- **AIR CONDITIONING—"FLUTTERING" NOISE FROM DEFROST DOOR DURING A/C FULL COOL MODE AND BLOWER MOTOR ON HIGH—VEHICLES BUILT THROUGH 1/1/2000**
- **NOISE—"FLUTTERING" HEARD WITH A/C FULL COOL MODE AND BLOWER MOTOR ON HIGH—VEHICLES BUILT THROUGH 1/1/2000**

Article No. 00-6-6

FORD: 2000 FOCUS

Figure 1 - Article 00-6-6

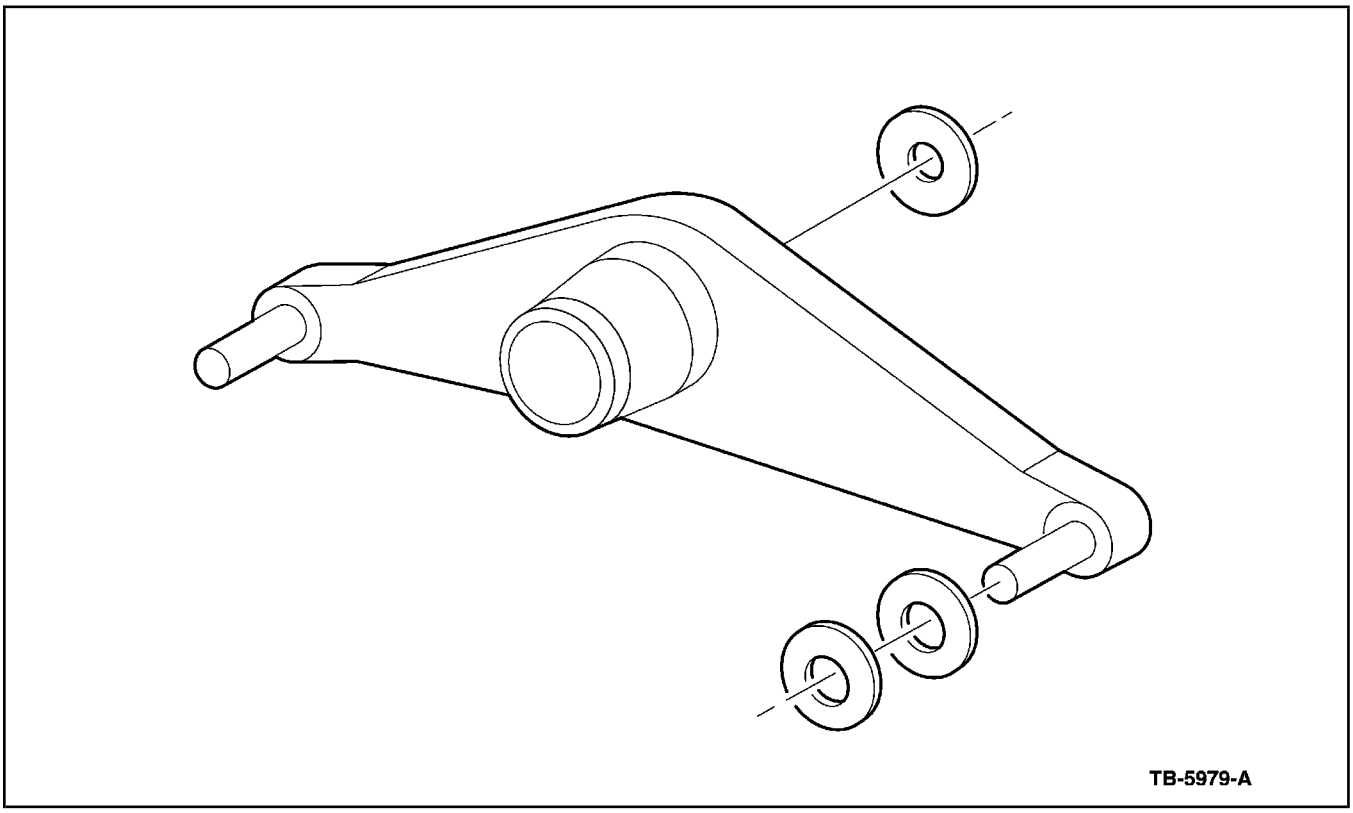
1. Locate the banana linkage on the plenum which is located under the driver side instrument panel on the plenum assembly. The banana linkage connects the gear box cam to the panel/defrost door crank on the air handling case (plenum).
2. Inspect the banana linkage and verify that all washers are in place and installed correctly. Two (2) black Washers (44711-S2) should be found between the banana linkage and the door crank. One gold Washer (E830293-S72) should be located under the banana linkage mounting screw. Install any missing washers (Figure 1).
3. If all the washers are present and correctly installed, tighten the banana linkage mounting screw 1/4-1/2 turn until the flutter noise cannot be detected.
4. Verify concern is corrected.
